## Design Exception #5

### Slopes at the MP 185 Cut Wall

I-70 West Vail Pass Safety and  
Operations Improvements

**DESIGN EXCEPTION MEETING**  
**AUGUST 23, 2021**

I-70 WB Cut Wall Typical Section ~ MP 187.5  
Wall at 25' From Ultimate Travelway

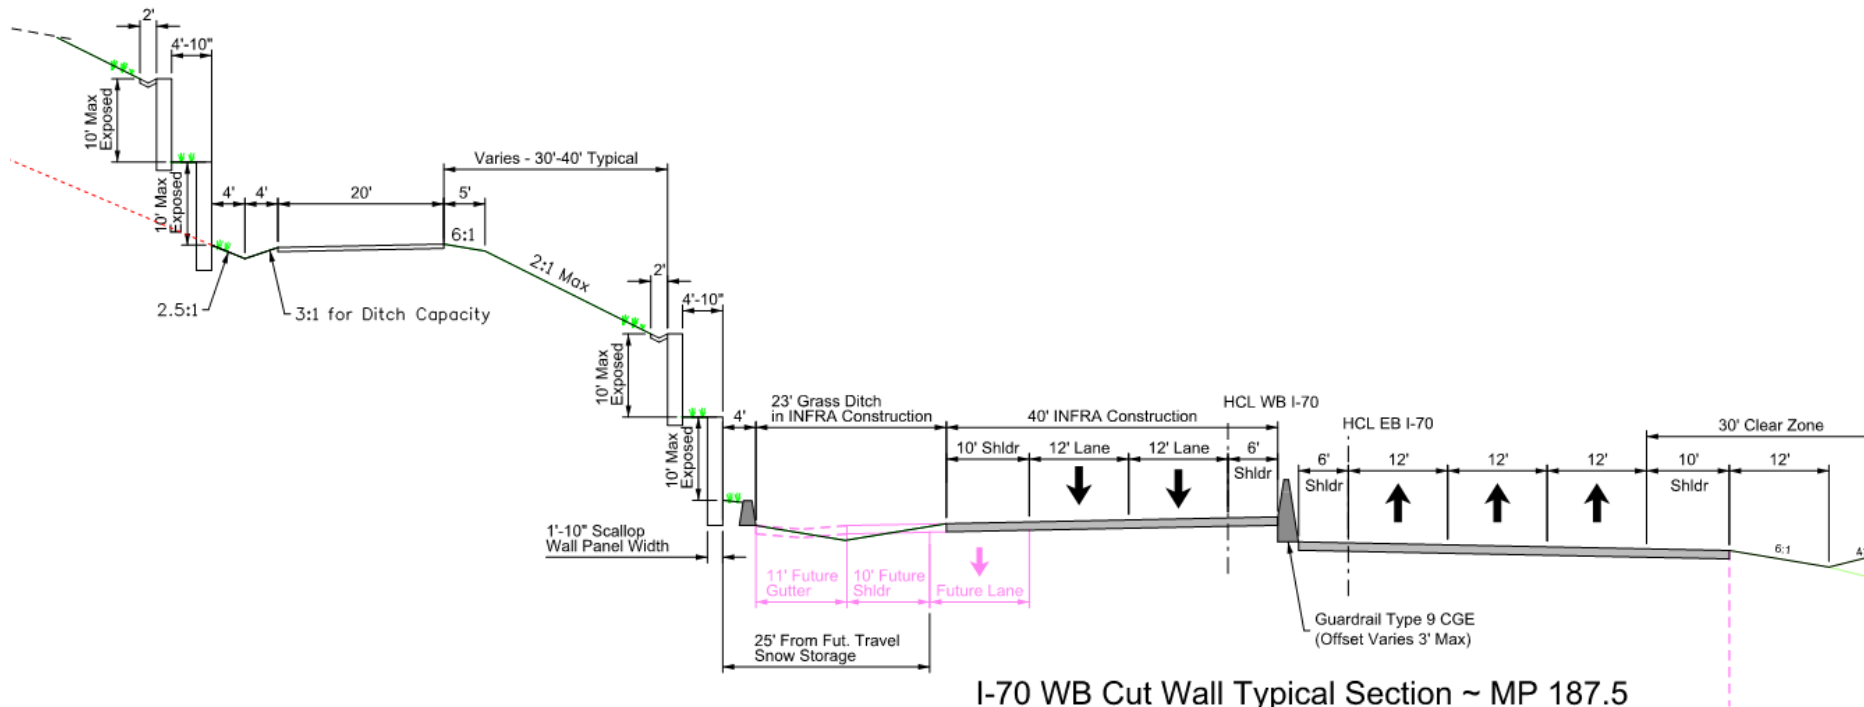
2. Greg said I know when we were talking about the roadway design and the bridges, you said the bridges were about 10' apart or parallel and then there was a space when you go to your section, it does not look like we have any kind of median.

Brian said it is shown incorrectly. On the westbound side we have the 6' inside shoulder and there will be a little bit more of an offset. We are working through the details of whether we need to have barrier on eastbound and westbound individually or whether we can have that CD barrier in the middle. There will be just a little bit of an open median through this section. This will be updated to show further separation as there is actually 8-9' feet in there.
